1822 Bank Street

URBAN DESIGN BRIEF

RESPONSE TO URBAN DESIGN COMMENTS

VIEW FROM ABOVE NORTHWEST SHOWING 45 DEGREE ANGULAR PLANE

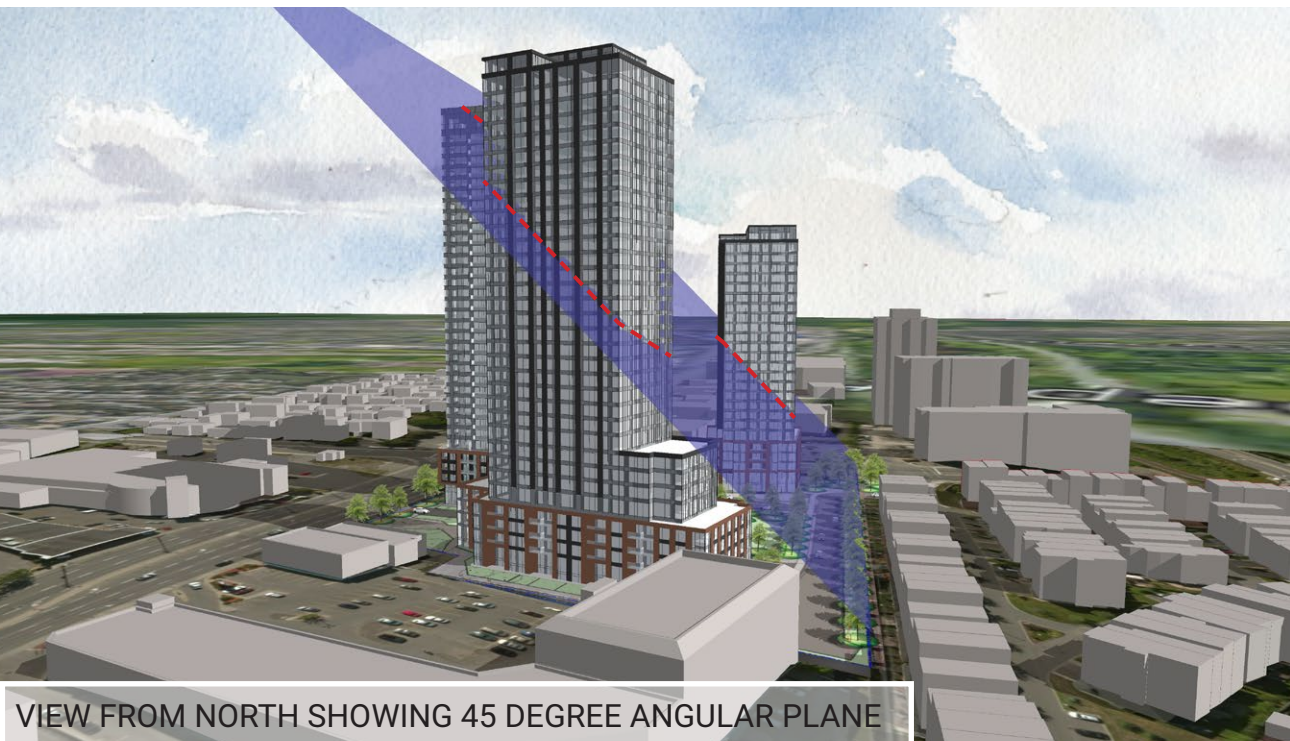
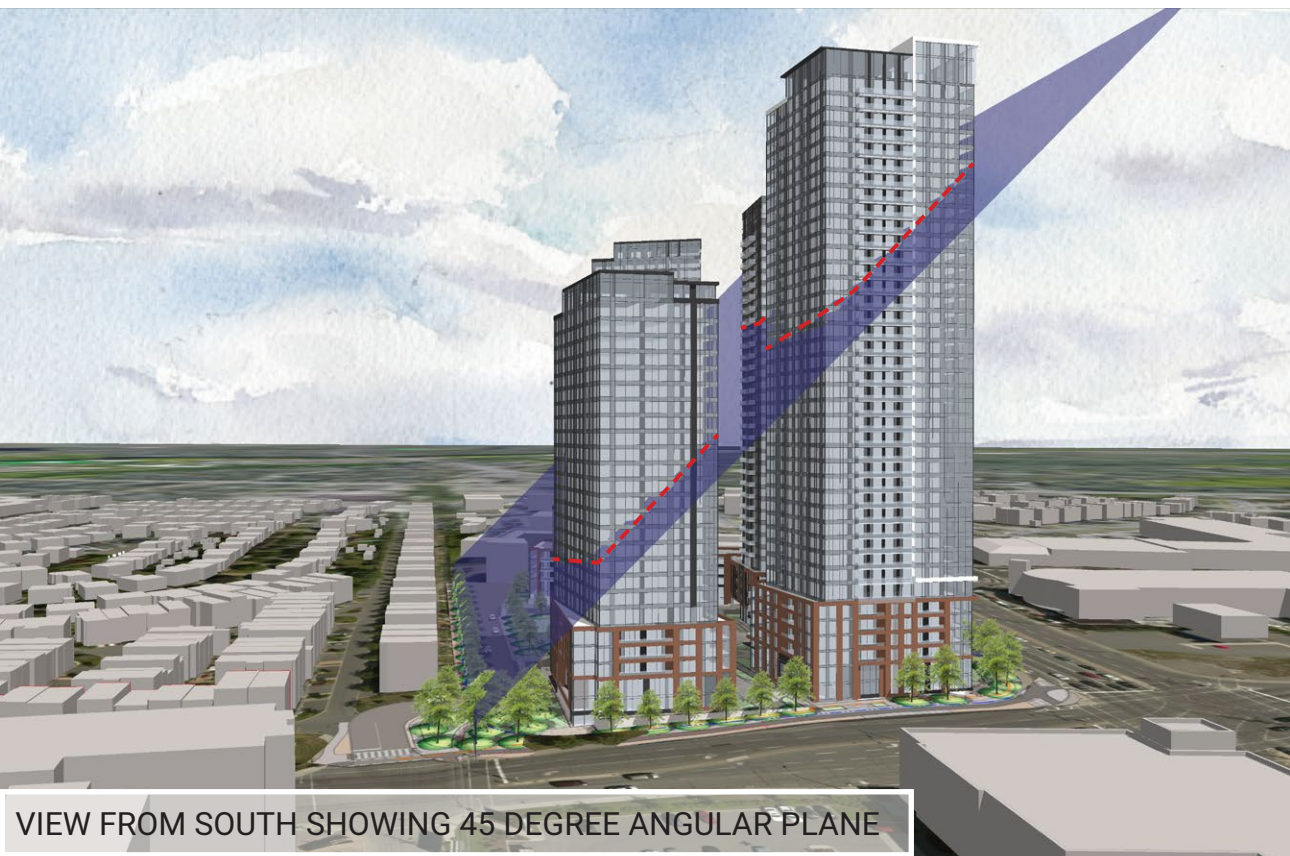
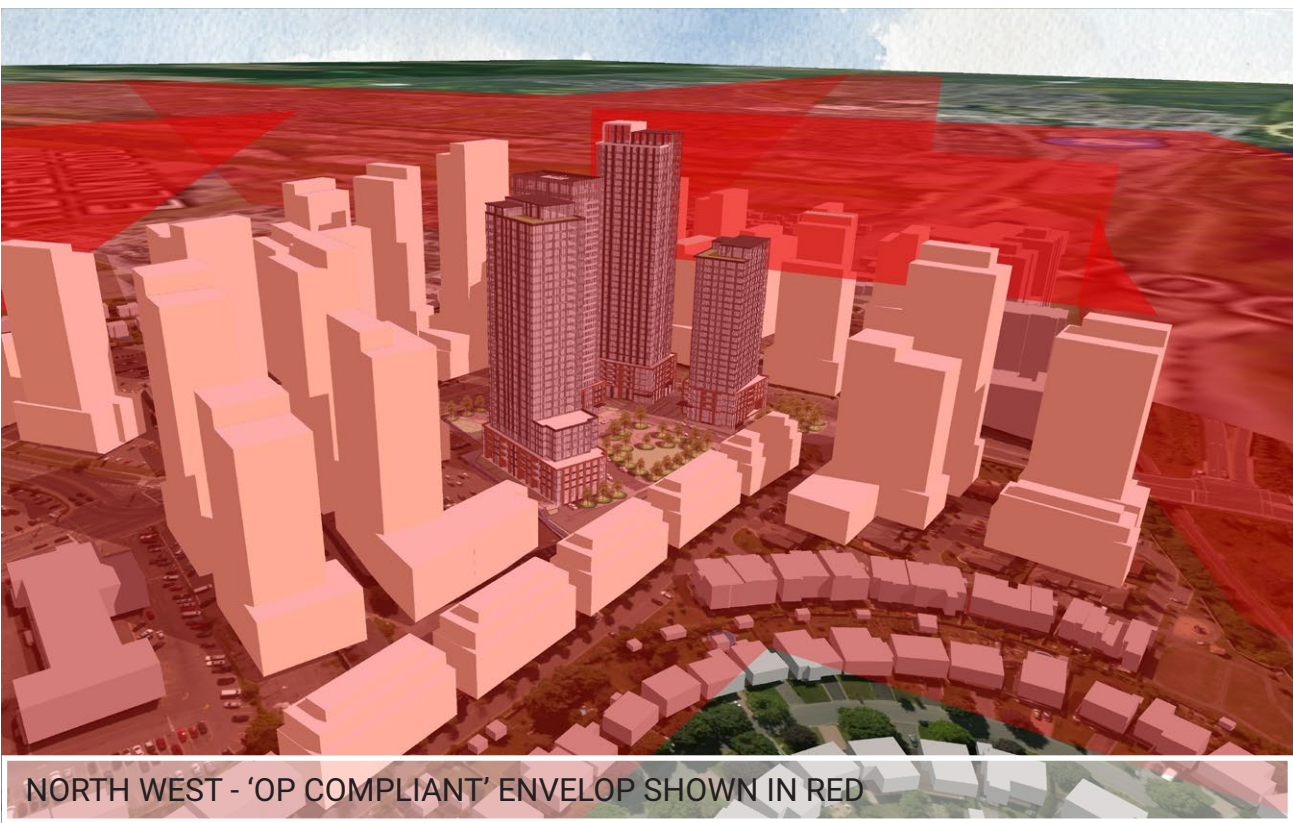
41. Ensure effective built form transition, guided by the application of angular planes.

Applicant: Please refer to the angular plane diagrams included in the UDRP submission set. We feel that the proximity to the transit station and future development potential under the OP justifies some elements of the development breaking the 45 degree angular planes. The trade-off the proposed development offers is providing the majority of the western edge as greenspace. This minimizes the number of the existing townhomes impacted by overlook / shadowing.

FUTURE DEVELOPMENT POTENTIAL

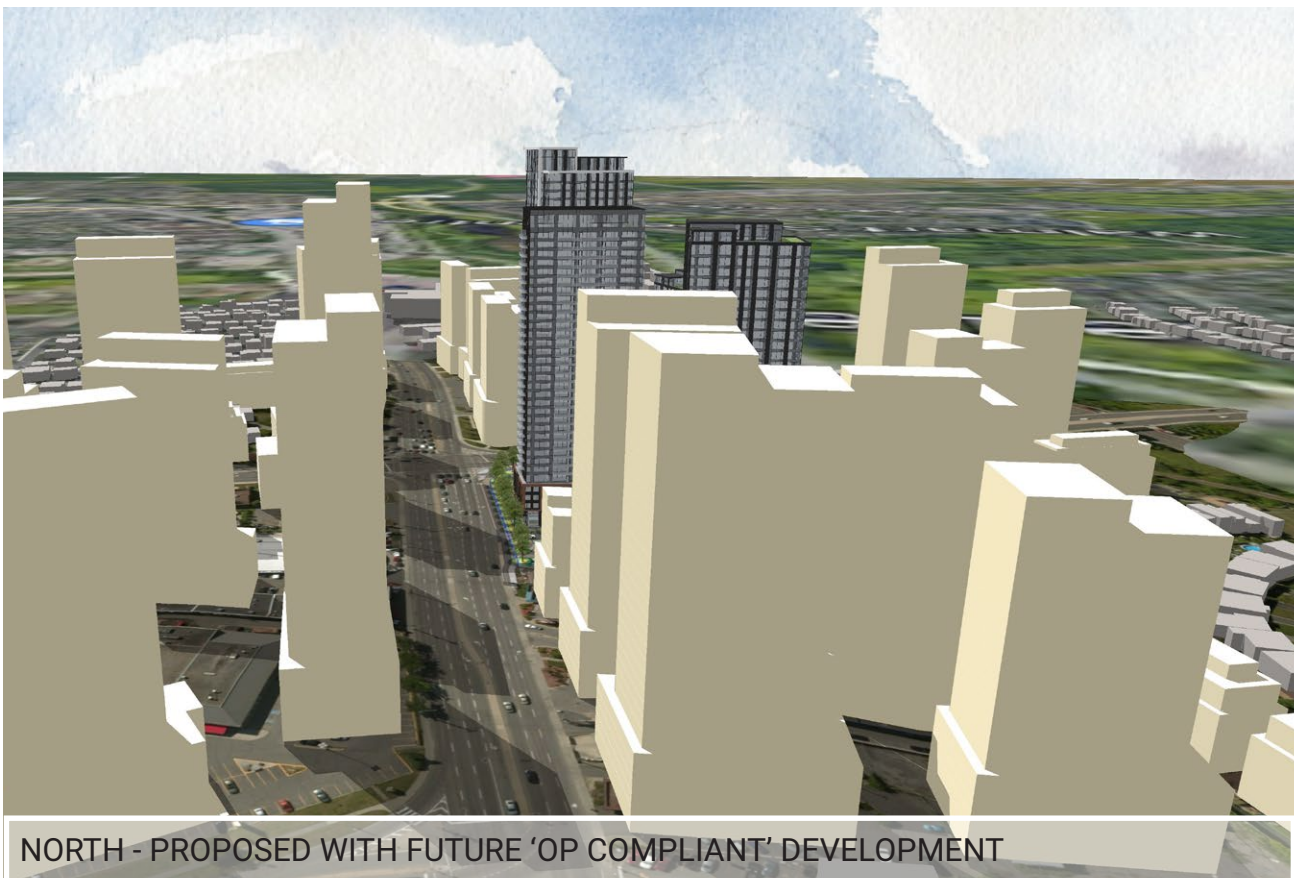
37. It is crucially important to explore and study block plan for the northwest quadrant of Bank and Walkley following directions of the Secondary Plan. A realistic block plan can offer clarity and provide guidance to the design of this site, including street and pathway connections, provision of parks and open spaces, and managing

relationship between neighbouring sites. Such a block plan can serve as a basis for the creation of a plan of subdivision. The attached diagrams illustrate how such a block plan may look like. Please note urban design is not recommending any of these block plan options. The purpose of these diagrams is to simply demonstrate that there may be a range of options and it is necessary to explore block plan options to inform the design of the site.

Applicant: In the UDRP submission deck we have included 'Future Development Potential' massing studies that look at how the blocks to the north may be developed out under the new OP frames and in a pattern that contemplates the extension a street northward to Alta Vista Drive.
